1 REDLINE REVISION 2/1/06

2 REDLINE REVISION 3/24/06
TEDD APPROVAL

MARYLAND DOT - STATE HIGHWAY ADMINISTRATION
Office of Traffic & Safety
TRAFFIC ENGINEERING DESIGN DIVISION

MD 190 AND LITTLE FALLS PARKWAY

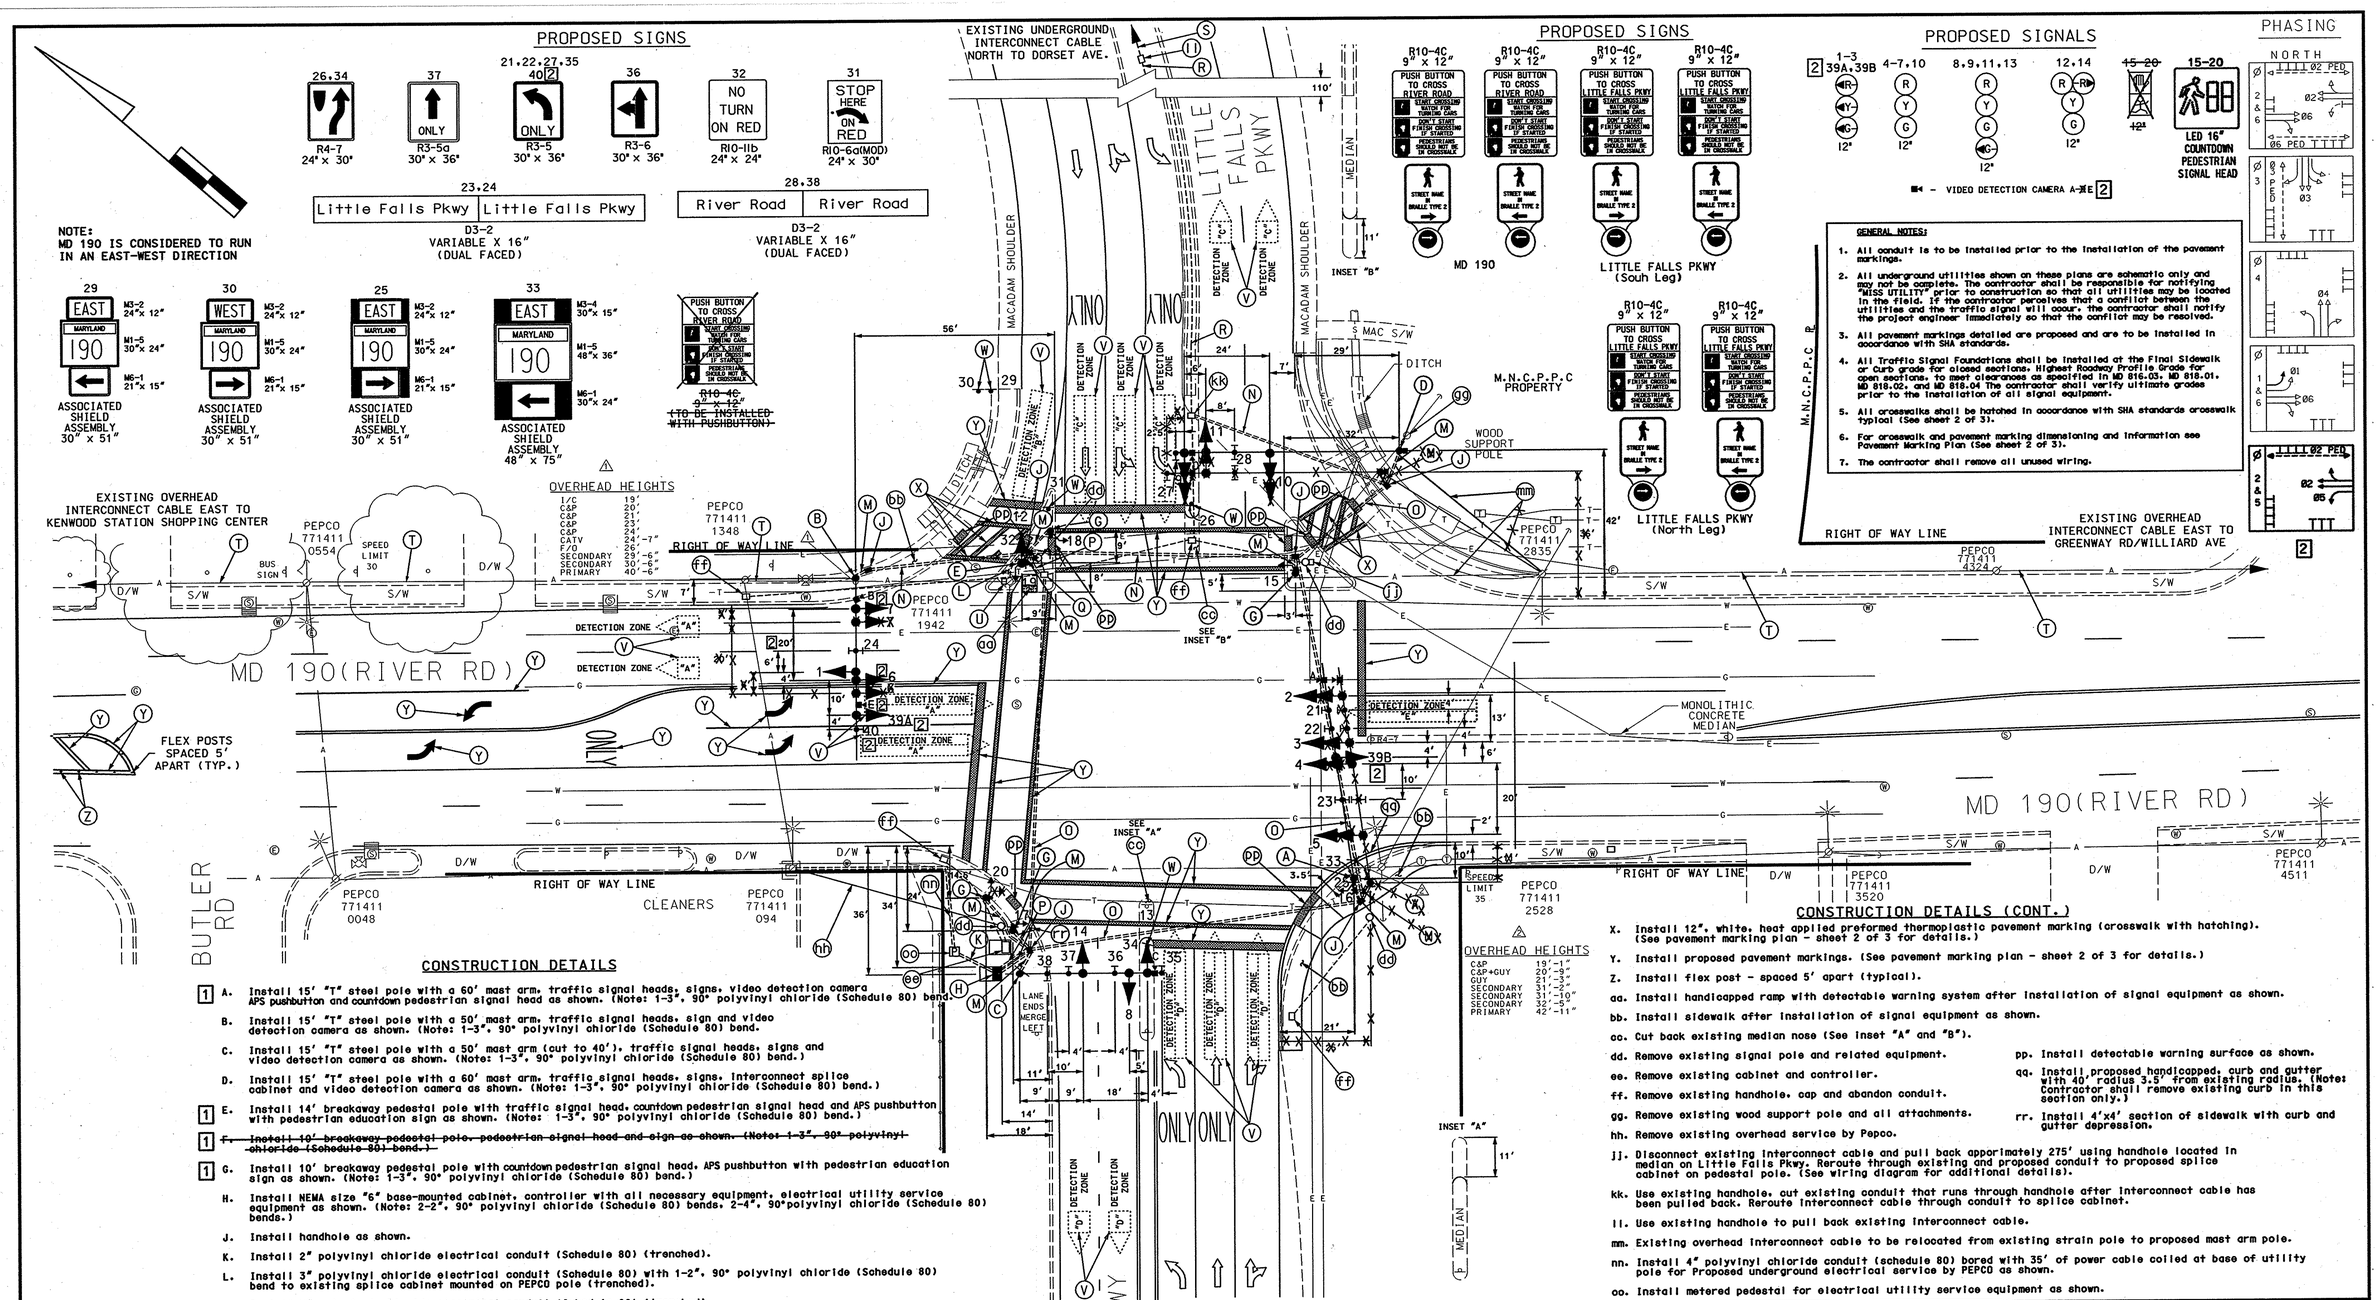
1 A. Install 15' "T" steel pole with a 60' mast arm, traffic signal heads, signs, video detection camera APS pushbutton and countdown pedestrian signal head as shown. (Note: 1-3", 90° polyvinyl chloride (Schedule 80) bend.)

1 E. Install 14' breakaway pedestal pole with traffic signal head, countdown pedestrian signal head and APS pushbutton with pedestrian education sign as shown. (Note: 1-3", 90° polyvinyl chloride (Schedule 80) bend.)

1 ~~F. Install 10' breakaway pedestal pole, pedestrian signal head and sign as shown. (Note: 1-3", 90° polyvinyl chloride (Schedule 80) bend.)~~

1 G. Install 10' breakaway pedestal pole with countdown pedestrian signal head, APS pushbutton with pedestrian education sign as shown. (Note: 1-3", 90° polyvinyl chloride (Schedule 80) bend.)
